Produktlinie Fahrerassistenzsysteme

Description of the Changes to the Sensor from ARS 2-A to ARS 2-C

June 6, 2003

Polarizing key of the connector

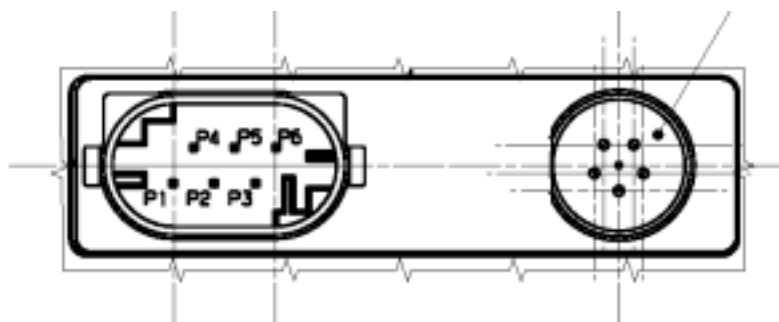
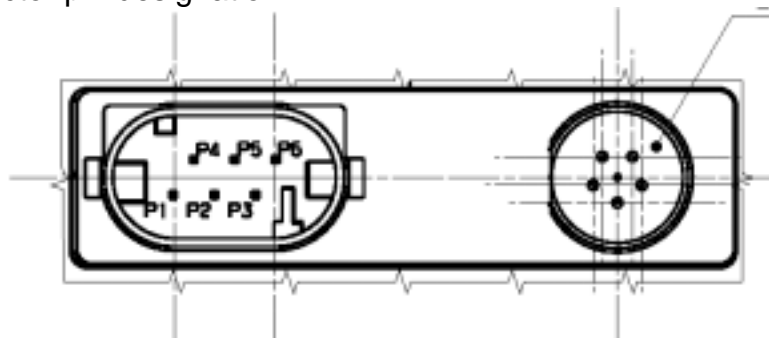
Polarizing key of the connector changed (see pictures below)
